UNITED STATES PATENT AND TRADEMARK OFFICE

APPLICATION NO.	FILING DATE	FIRST NAMED INVENTOR	ATTORNEY DOCKET NO.	CONFIRMATION NO.
09/855,853	05/15/2001	Stefan J. Murry	PAT013	1173

Office Action Summary

**FIG. 6**

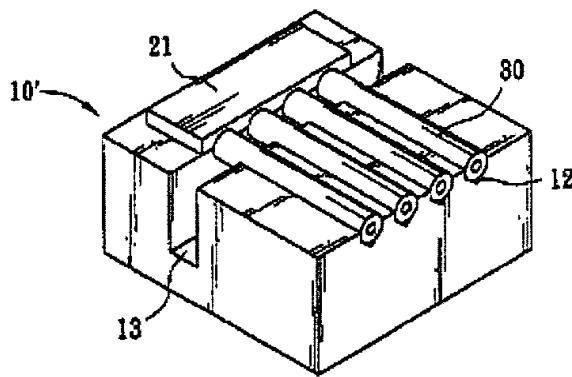
Claims 1,4,7,8,10,12,18,19,20-26,32-42 are rejected under 35 U.S.C. 102(e) as being anticipated by Wu et al (US 2002/0037137).

Figure 6 illustrates an array of vertical cavity surface emitting lasers (21) mounted on a slot (11) (not shown see figure 2) and an array of optical fibers (30), where the lasers and the fibers are all mounted on a silicon substrate. The lasers emit a light, which is optically coupled to the edge of the fiber.

FIG. 1
(PRIOR ART)

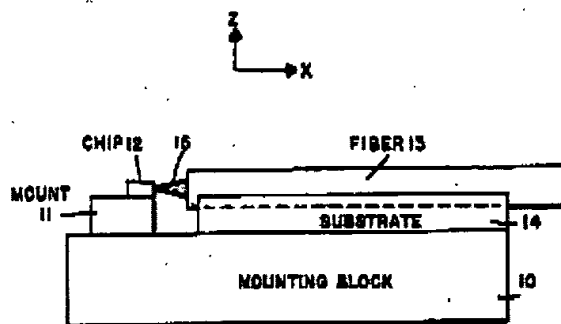
Furthermore, direct coupling of a laser with an optical fiber is well known in the art as shown in figure 1 of Melman.

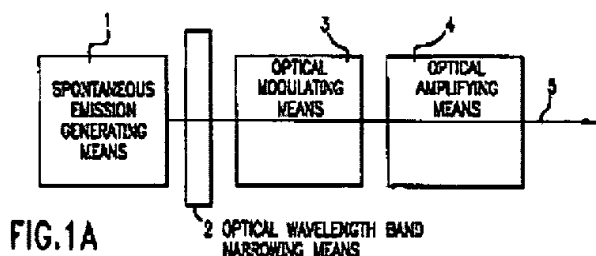
In figure 6 Wu et al illustrates an array of vertical cavity surface emitting lasers (21) mounted on a slot (11) (not shown see figure 2 and an array of optical fibers (30),

Wu et al does not disclose coupling modulators, amplifiers and SOA with the array of lasers.

Coupling of optical modulators, optical amplifiers or any other optical element within a laser system is well known in the laser art and would be within the level of skill of any person having ordinary skill in the art, which understands the scientific and engineering principles applicable to the claimed invention, as shown in figure 1A of Ota et al.
